**Re: Further Action at the following Site:**

- **Site Name:** Former Norge Laundry & Cleaning Village
- **Site Address:** 869 Commerce Ave., Longview, Cowlitz County, WA 98632
- **Facility/Site No.:** 6101
- **Cleanup/Site No.:** 258
- **VCP Project No.:** SW1065

The purpose of this opinion letter is to provide Ecology's comments regarding PBS' *Work Plan for Final Site Characterization*. As the SW1065 cleanup is currently being completed under WAC 173-340-515, this cleanup is being conducted without Ecology oversight or approval. However, Ecology can determine whether the remedial actions meet the substantive requirements of MTCA and/or whether further remedial action is necessary at the Site. Additionally, Ecology can also provide concurrence or comments regarding work plans, proposed remedial actions, sufficiency of the remedial investigation, feasibility study, or proposed cleanup action.

PROPOSED BORING LOCATIONS

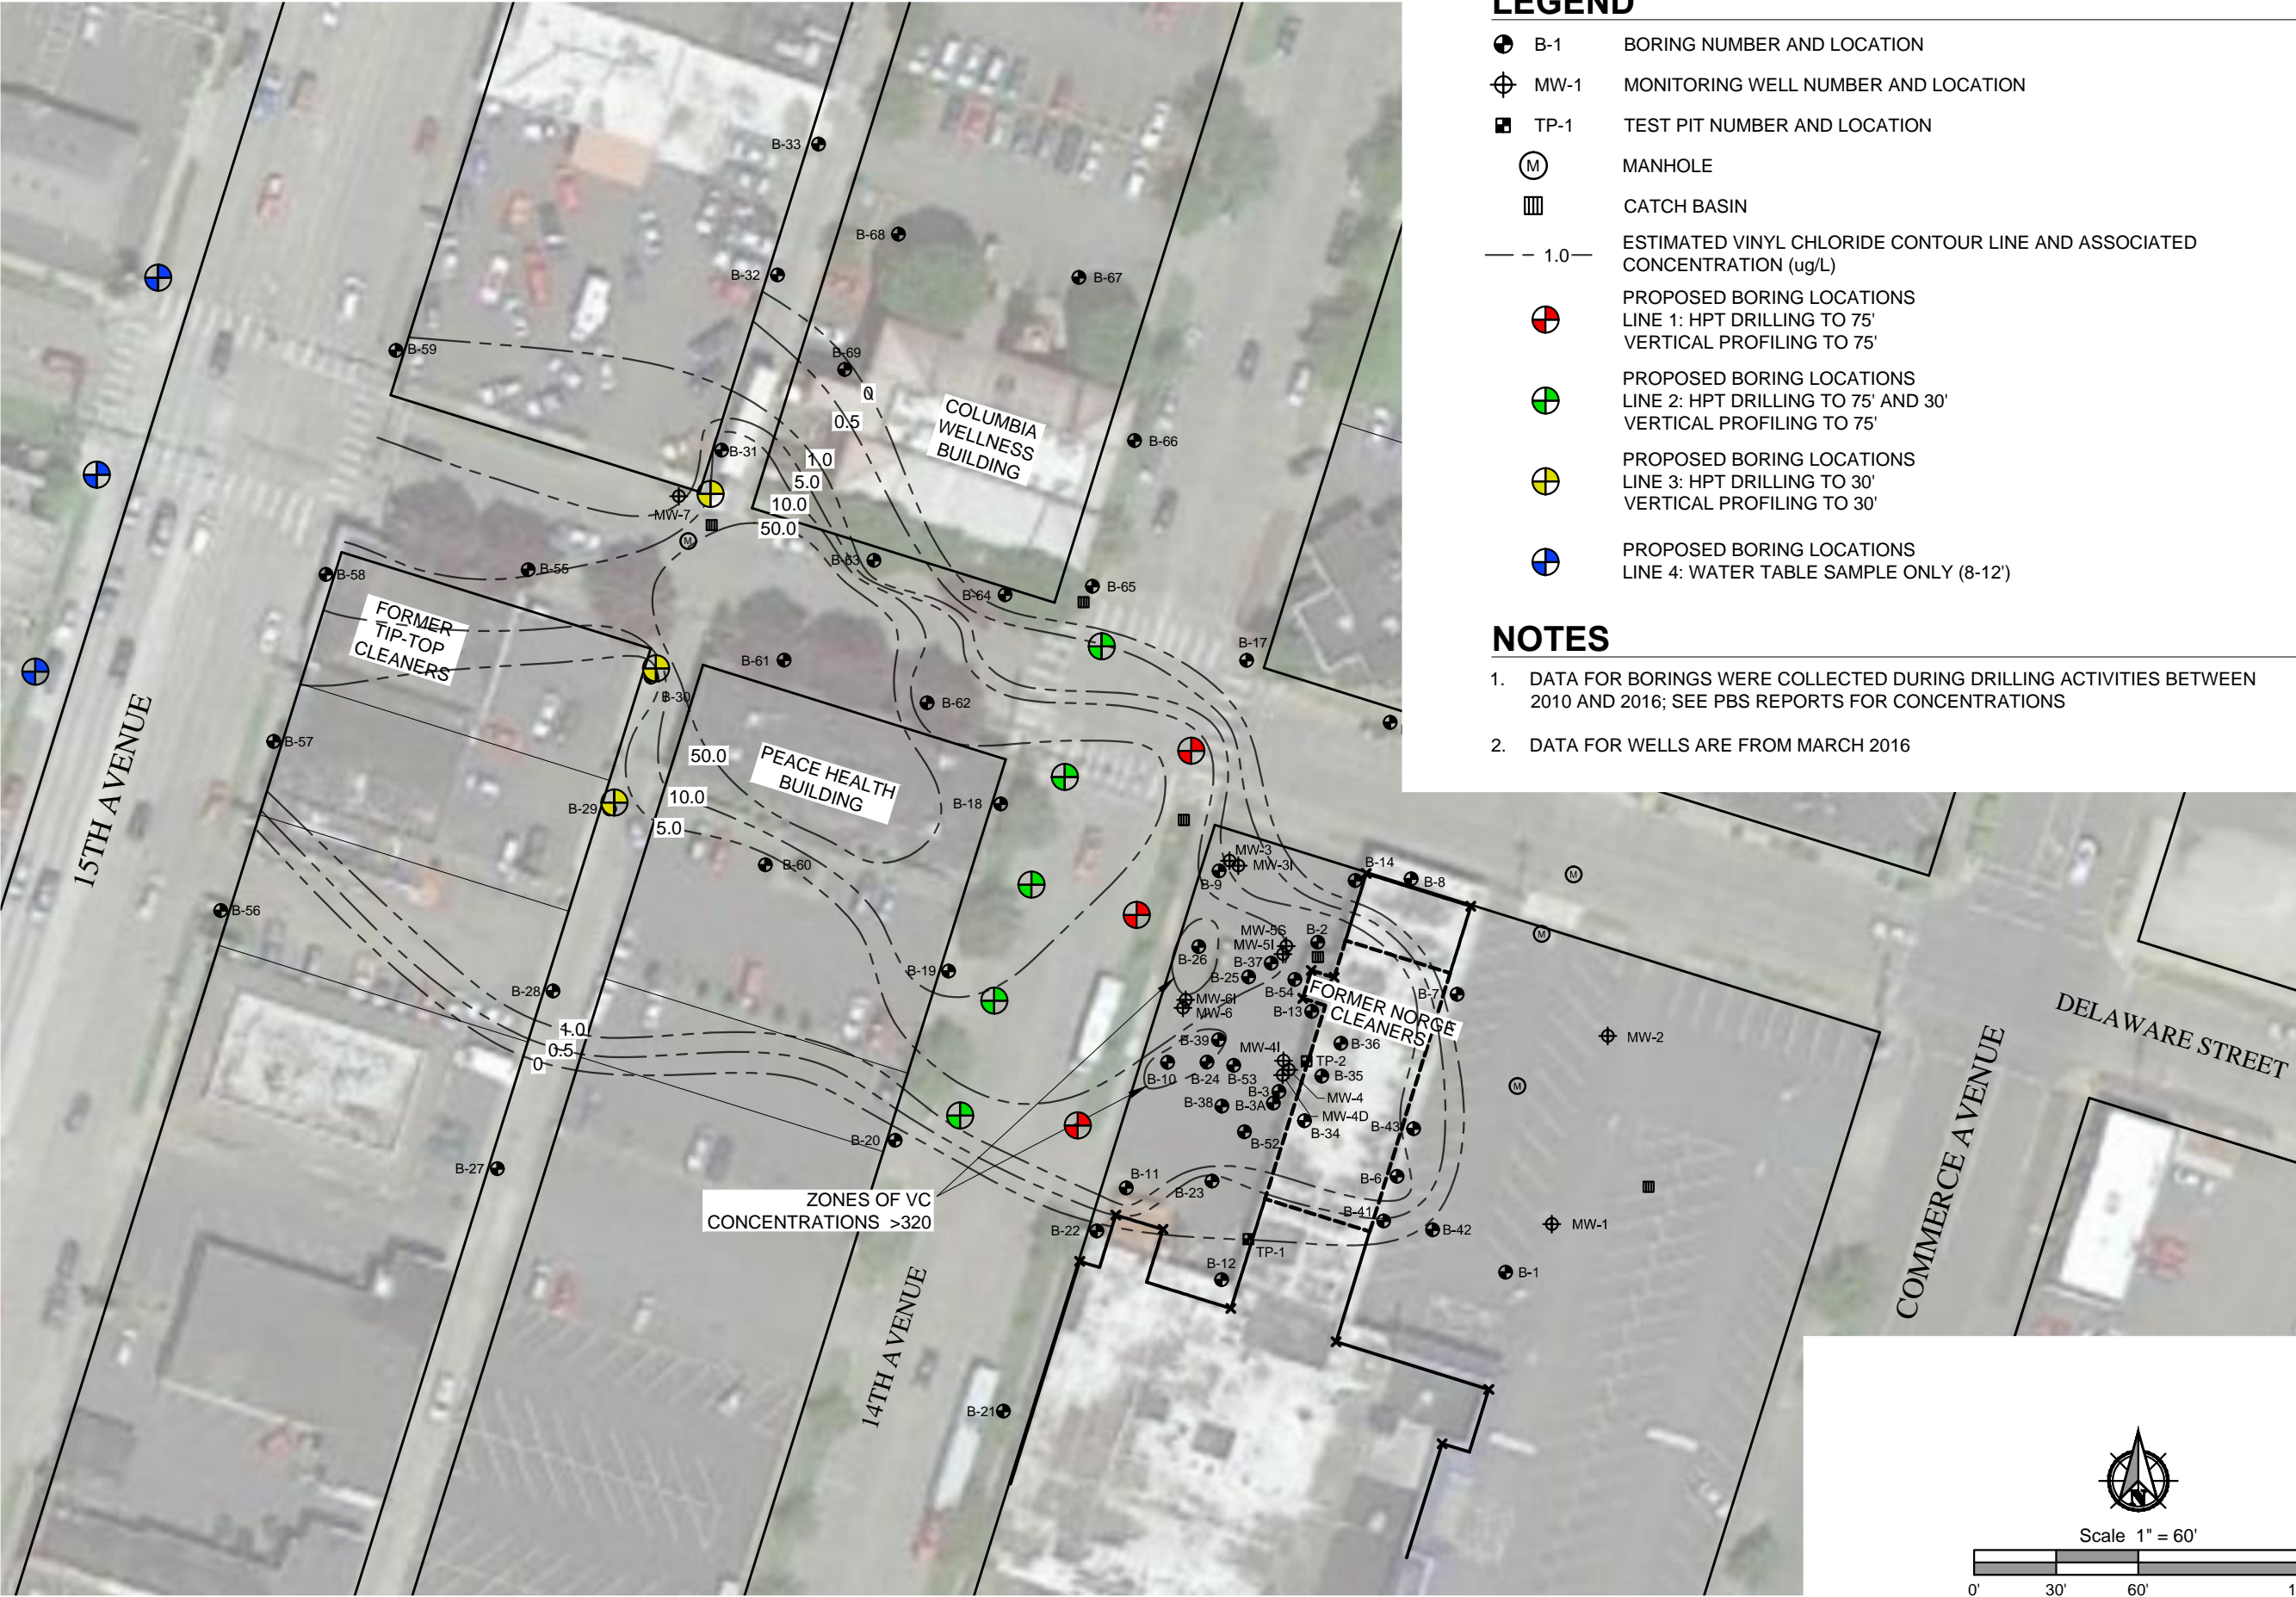
2. The proposed green hydraulic profiling tool (HPT) boring located to the northeast of boring B-18 will be useful to determine if the Peace Health Building sump is pulling the groundwater plume towards this location. If the foundation sump is pulling the groundwater plume towards it (and between historical sampling locations B-18 and B-62), the building sump might be transferring the plume via discharge from the sump to the storm water system on the western side of the Peace Health Building. This might explain why Site COCs are in groundwater in the vicinity of the intersection of the alley way and Delaware Street and identified in the storm water outfall sampling. The proposed location would likely close any data gap in this area.

3. It appears that the blue proposed non HPT boring locations<sup>2</sup> are likely necessary to define vinyl chloride contamination in shallow groundwater to the northwest (downgradient). Additional locations to the north may be required if the groundwater

plume is more extensive than expected. Vinyl chloride at grab groundwater boring locations B-57, B-58, and B-59 appear to require further vertical delineation. Permanent monitoring wells are recommended to define the downgradient portion of any plume in groundwater.

- a. Ecology suggests generating rose diagrams for all water bearing zones to evaluate groundwater flow direction variability.
  - b. If groundwater flow direction is determined to flow in a different direction than generally northwest, please clarify how deeper aquifer contamination has been areally delineated. In order to delineate intermediate and potentially deep groundwater contamination, it may be appropriate to complete HPT borings and sampling along the northern Property boundary and to the south and southwest of MW-4. Alternatively, analysis of flow directions may demonstrate that any area southwest of a potential intermediate groundwater plume may be covered by an additional point to the south in the “red line” of proposed HPT boring locations.

7. Consider advancing one or two HPT borings in an east-west orientation along the northern Property boundary to refine the extent of the shallow groundwater plume (currently delineated to the north by groundwater results for B-15, B-16, and B-17). The value of refining the northern extent is to determine if the plume actually extends onto the parcel to the north, as the road centerline may be the extent of the Property<sup>5</sup>.

8. Please clarify how the on-Property sewer line<sup>6</sup> has been evaluated. Groundwater sampling locations such as B-7 and B-43 appear to be approximately 30 feet away from where the sewer lateral would exit the building. Grab groundwater sample results at B-7 (PCE and TCE) and B-43 (PCE and vinyl chloride) exceeded the MTCA Method A cleanup screening levels. Ecology suggests at least a couple of HPT borings along the sewer line completed within the shallow groundwater bearing zone.
